Memorandum to the City of Markham Committee of Adjustment

File: A/070/24
Address: 94 Tomlinson Circle, Markham
Agent: Rijo Build Inc. (Jonathan Slaa)
Hearing Date: Wednesday, August 14, 2024

The Applicant is proposing to construct a one-storey, 20.6 m² (221.7 ft²) covered unheated sun deck with an attached 11.5 m² (123.8 ft²) deck (the “Proposed Development”) (refer to Appendix “B” – Plans).

① SITE PLAN
1 : 175

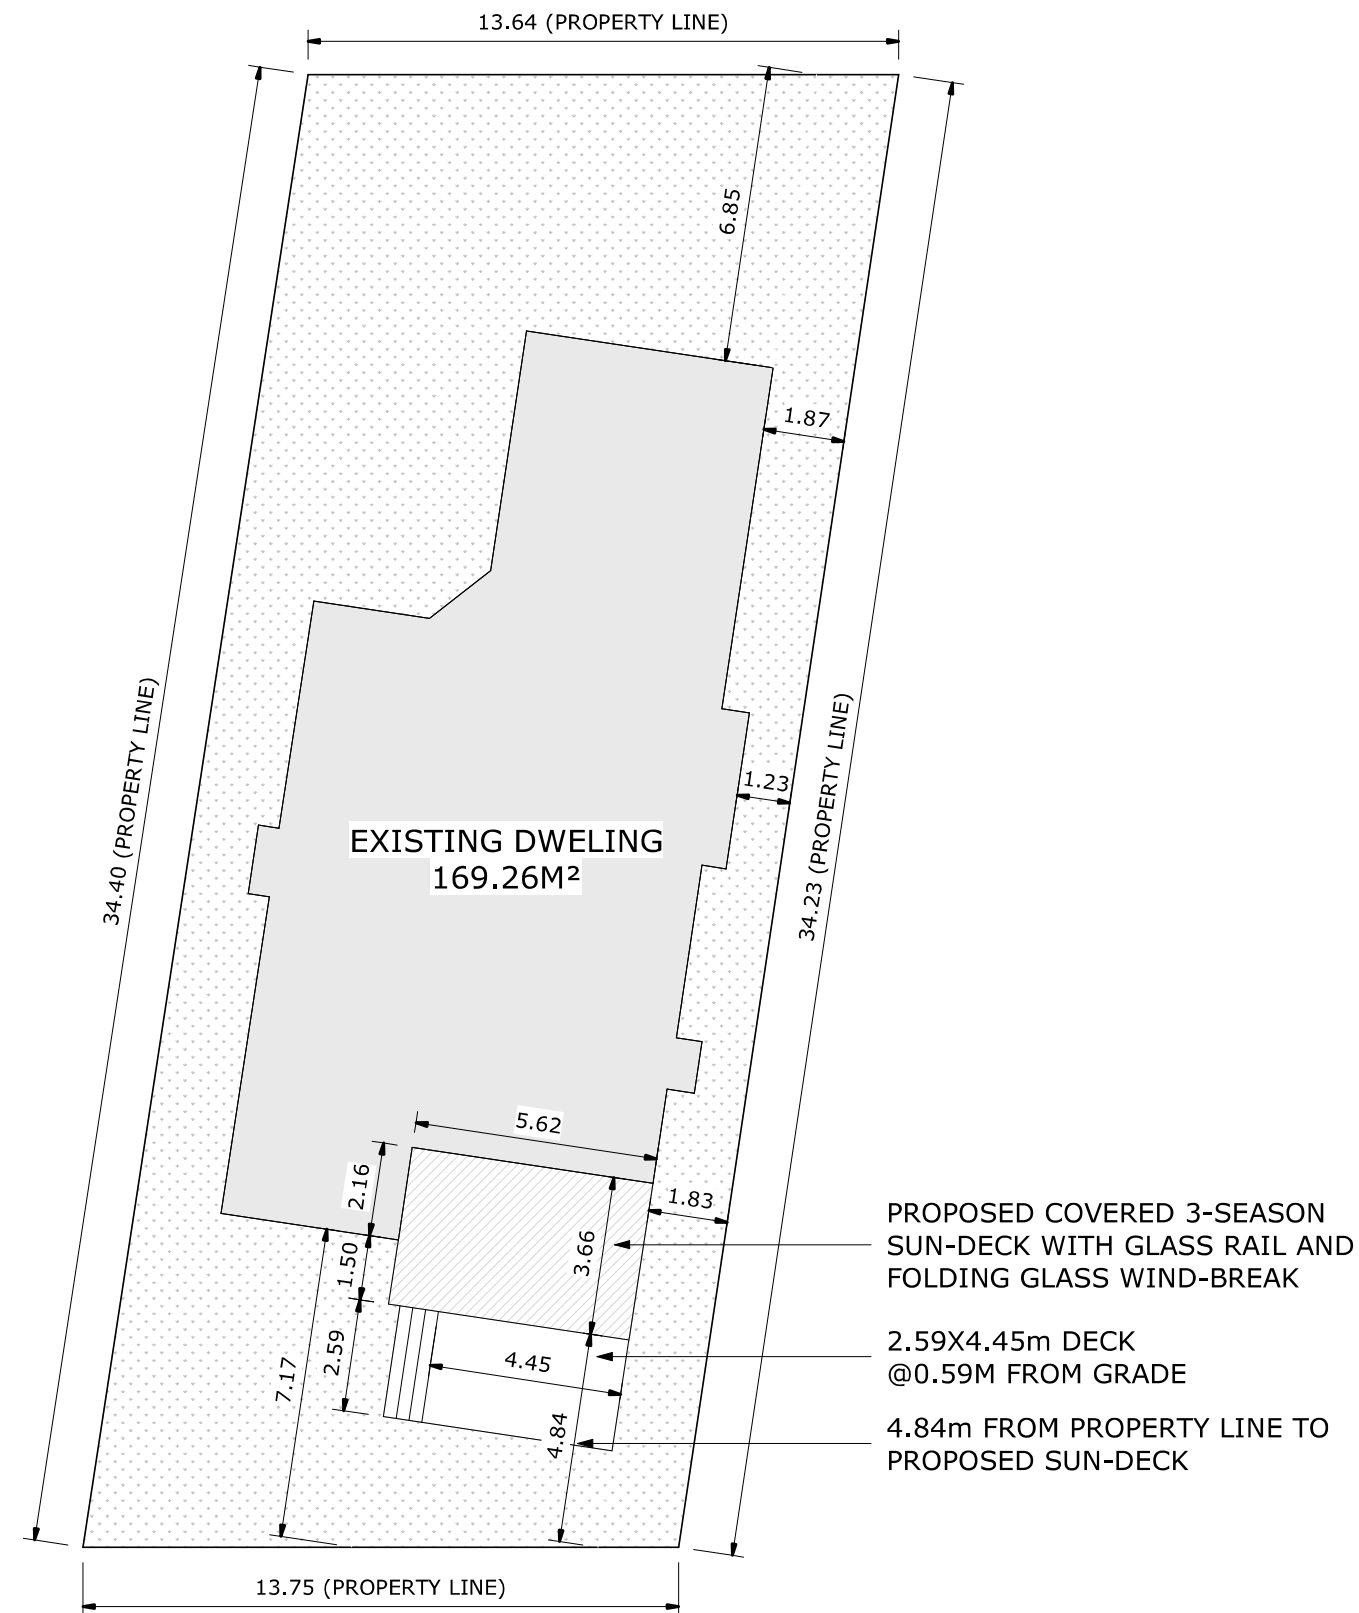
This variance is tied to the requested rear yard setback of 4.84 m (15.87 ft) associated with the Proposed Development. The uncovered deck projects approximately 2.59 m (8.5 ft), which is 53 percent of the requested 4.84 m (15.87 ft) rear yard setback.

Engineering Staff have reviewed the application and have no concern with the requested variance as it relates to site drainage. Staff are of the opinion that the variance is minor in nature and have no concern with the requested variance given that the proposed deck projection is smaller than what would be permitted and is in keeping with the building's east wall line.

The Applicant is requesting relief from By-laws 2024-19 and 118-79, as amended, to permit a minimum rear yard setback of 4.84 m (15.87 ft), whereas both By-laws require a minimum rear yard setback of 7.5 m (24.6 ft). This represents a reduction of approximately 2.66 m (8.73 ft).

The variance is entirely attributable to the proposed rear covered sun deck on the east portion of the main rear wall. The west portion of the main rear wall of the building provides a rear yard setback of 7.17 m (23.52 ft), which still meets the reduced rear yard setback approved in 2014. Staff are of the opinion that the requested variance will not have a marked impact to adjacent properties and are minor in nature, as the Proposed Development does not span the entire width of the building and maintains the existing side yard setbacks.
